NUMBER
PTR13059

LINE	QUANTITY	UOP	CAT NO	ITEM NUMBER	UNIT PRICE	AMOUNT
ADDENDUM NO. 01						
THIS ADDENDUM IS ISSUED TO MODIFY THE ORIGINAL SOLICITATION PER THE ATTACHED DOCUMENTATION.						
0001	1	EA		557-05		
176" WHEELBASE BUSES (18 PASSENGER CUTAWAYS)						
***** THIS IS THE END OF RFQ PTR13059 ***** TOTAL:

This addendum is to provide answers to technical questions and approved equals.

TECHNICAL QUESTIONS/ APPROVED EQUALS ON PTR13059

Appendix A

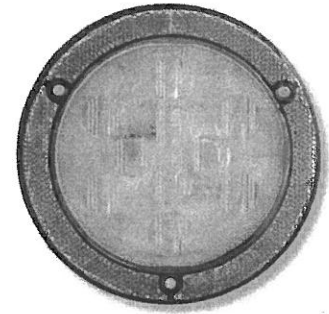
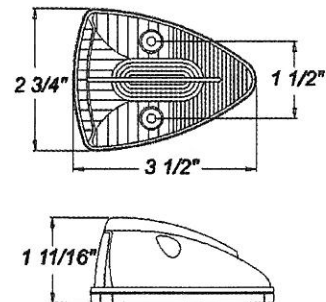
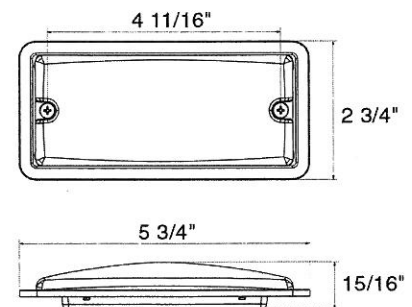
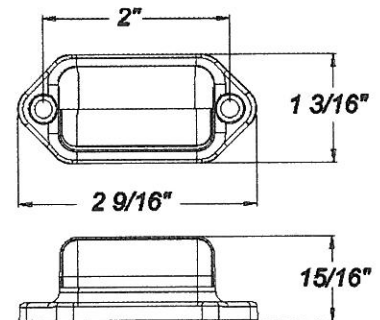
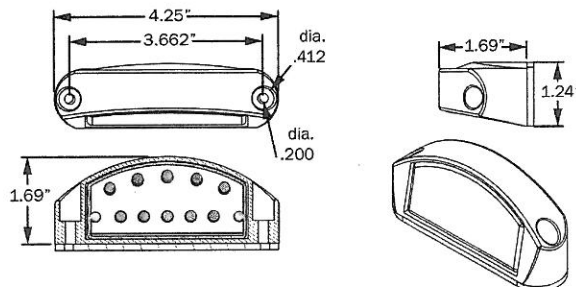
- 3.9.3 In lieu of Sound Off brand lights, please accept our standard Optronics brand of exterior LED lights, as described in the attached literature.
Approved. See Appendix A attached.

- 3.9.4a In lieu of Gustafson brand lights, please accept our standard Optronics brand of interior LED lights, as described in the attached literature.
Approved. See Appendix A attached.

Drawing Name / Description:
FLOOR PLAN, GCII 18P/2WC/186WB/308BDY

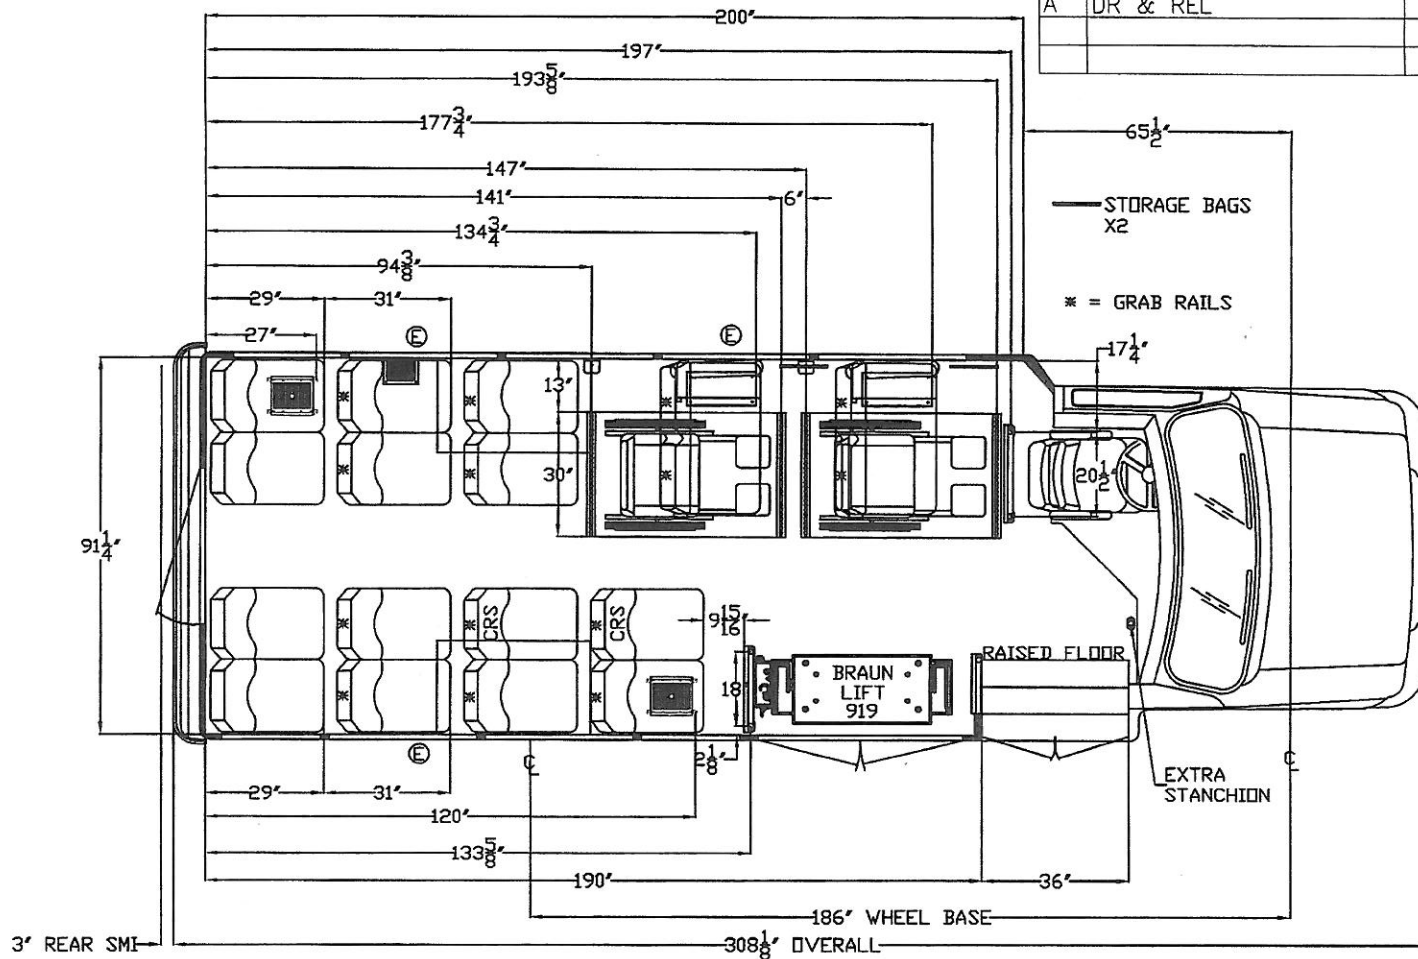
- 4.3, 4.4, 4.5, 4.6, and 4.7 This option calls for the addition of a 3rd wheel chair position. In the past the division has received the attached floorplan labeled Front Lift Floorplan. It only has two wheelchair positions but maximizes ambulatory passenger capacity which we believe agencies are looking for and are used to. Would this floorplan be acceptable for the extended Body Length Front Lift Option?
If the 3rd wheelchair position is required please advise as to the Number of Fixed Ambulatory Passenger Seats and Foldaway Ambulatory seats required or provide sample floorplan.
Two wheelchair positions are all that are required for our purposes. Classes D, E, F, and G requested the extended body to accommodate the front lift position and front to back orientation of securement spaces. 4.7 should have the extended length and the side by side orientation of wheelchair securement positions with a rear lift. Please see Appendix B.

Appendix C

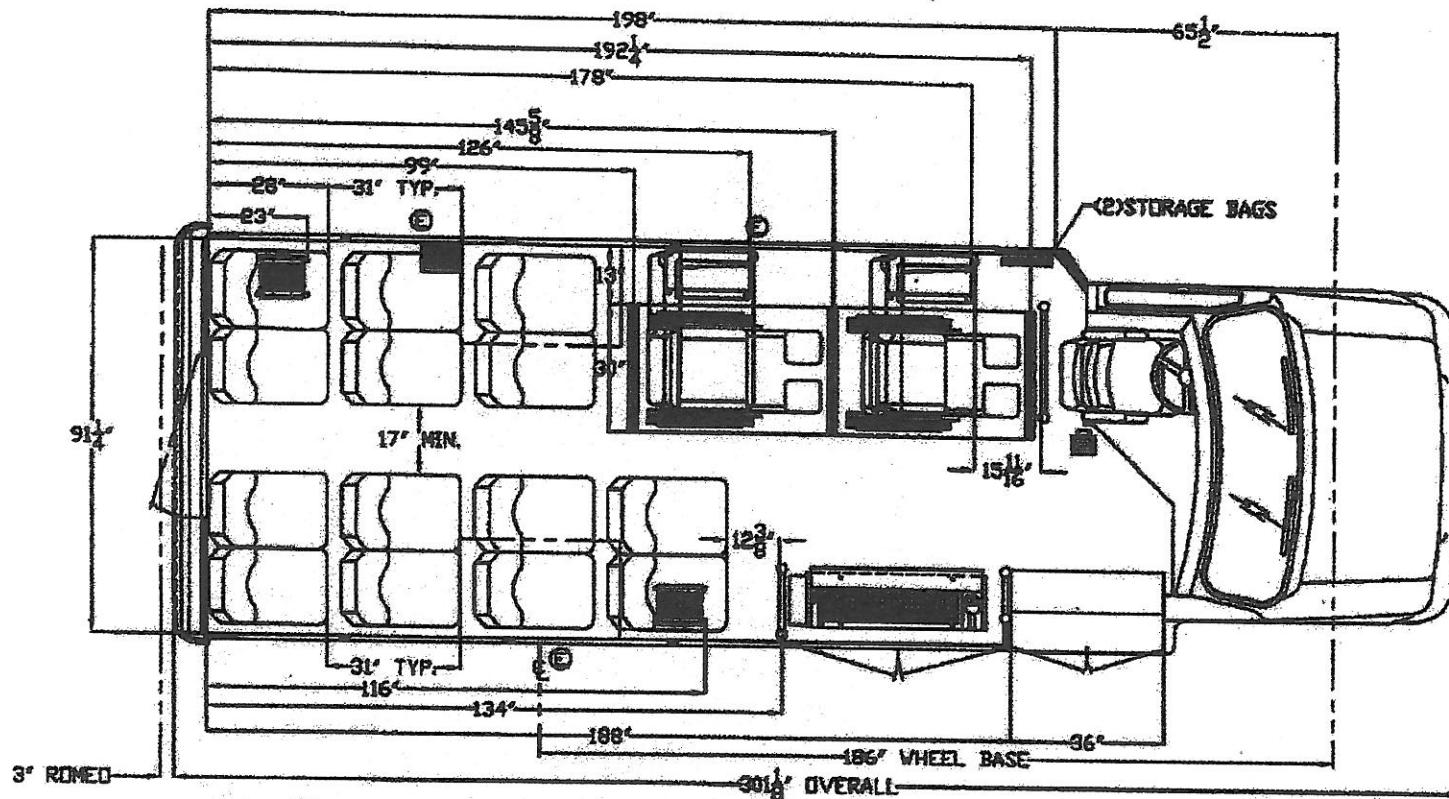
Please find the floorplans that were inadvertently omitted on the original specifications attached at Appendix C.
